1704 Latton Water Treatment Works Tender Change Control Tracker

Issue 01 - 25 April 2025 (work in progress issue)
Issue 02 - 02 May 2025
Issue 03 - 02 May 2025

project	1704	project	Latton Water Treatment Works
document	D07 - 03	title	Tender Change Control Tracker
issue date	02/05/2025	scales shown @ A3

16. Gravel border to be omitted from perimeter of building.

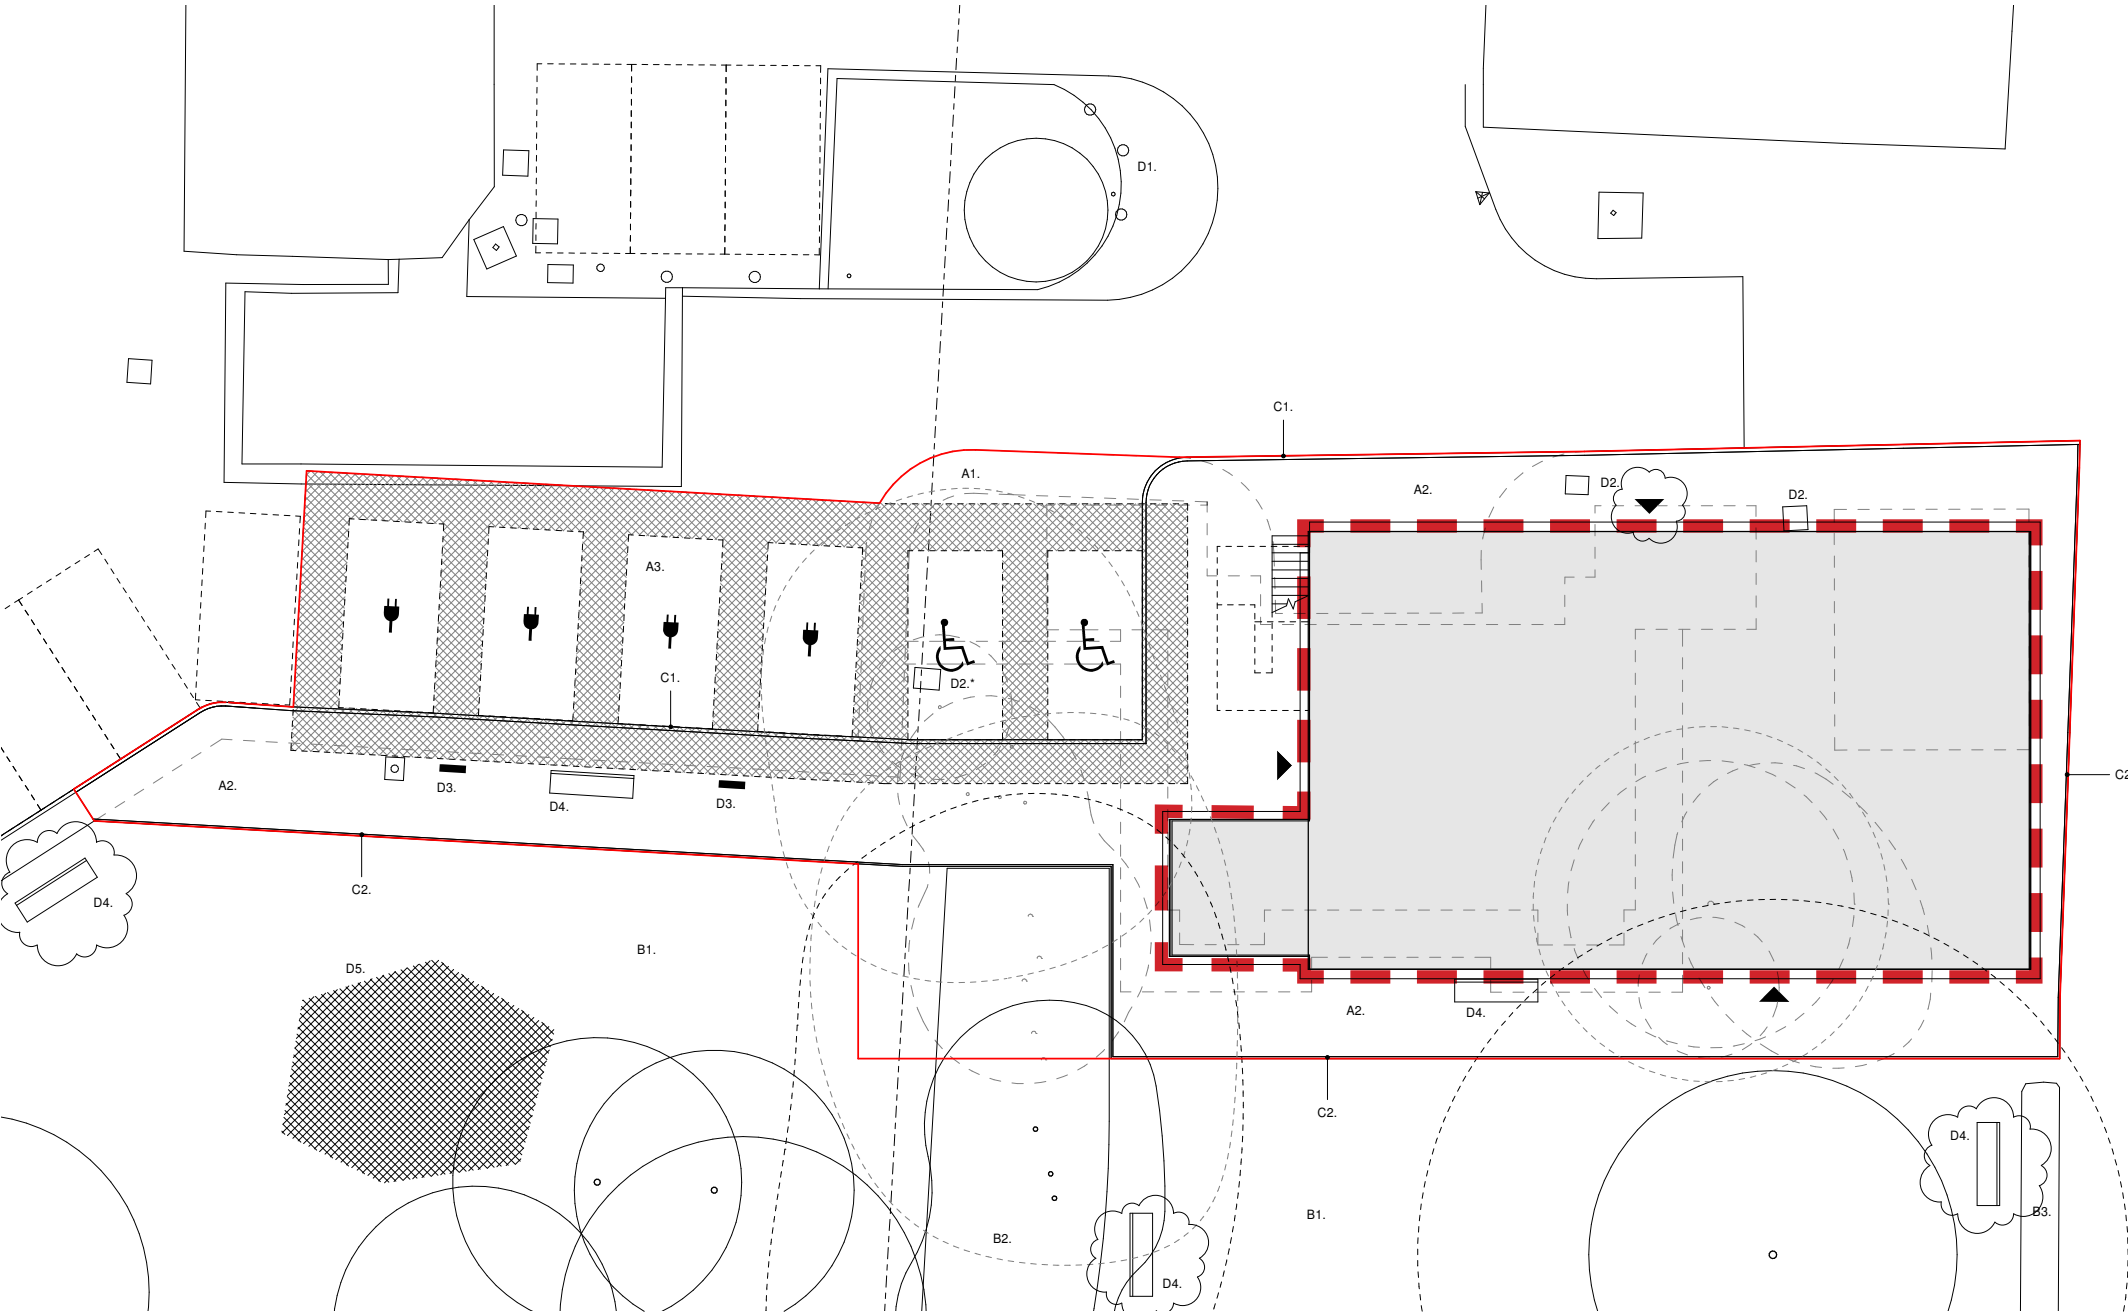
- 01. Gravel border to be omitted from perimeter of building, concrete pin kerb installed against face of stone cladding, concrete surfacing to continue up to pin kerb subject to commend from cladding supplier.

Client instruction.

Confirmed 25/04/2025.

17. Update solar array layout to match specialist subcontractor design proposal.

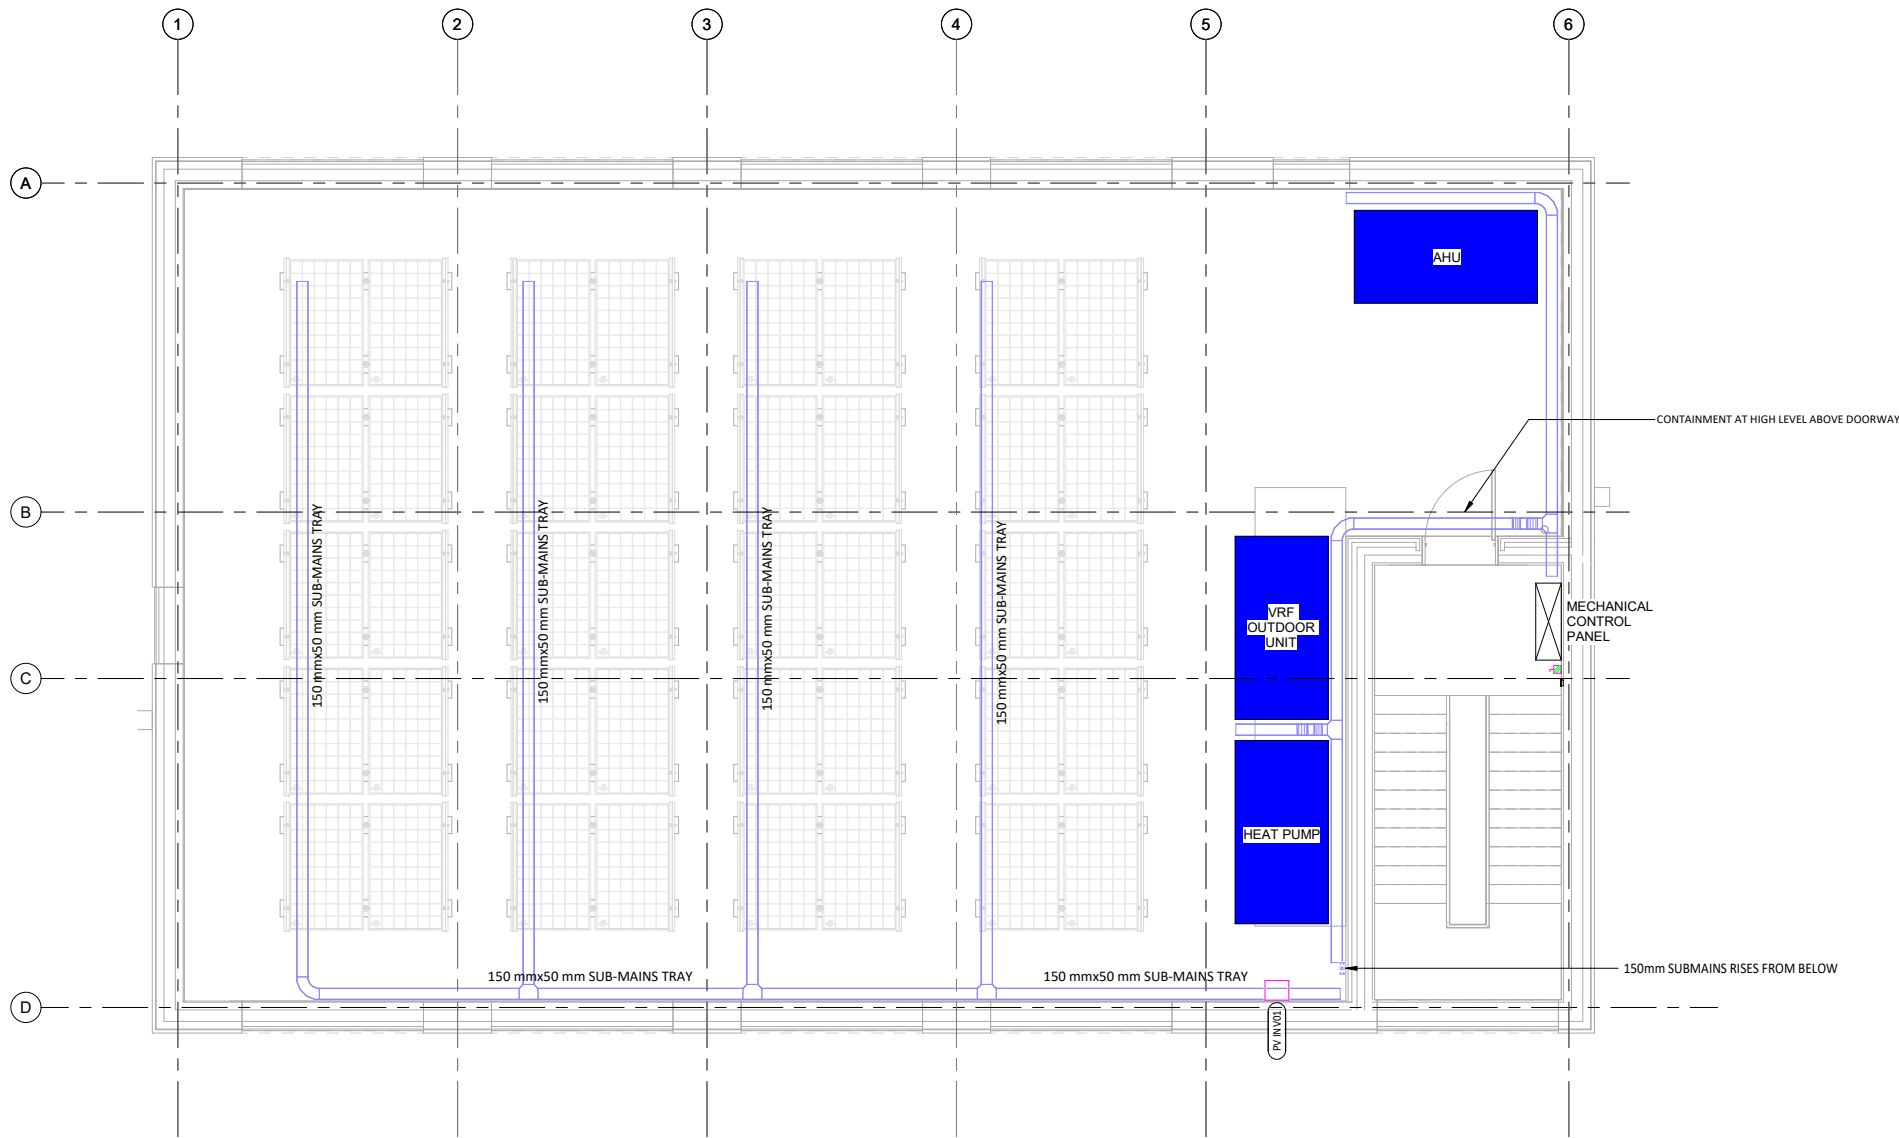
01. Architectural roof plan drawing to be amended to suit solar PV layout on service engineer’s drawings.

Subcontractor design coordination.

Confirmed 25/04/2025.
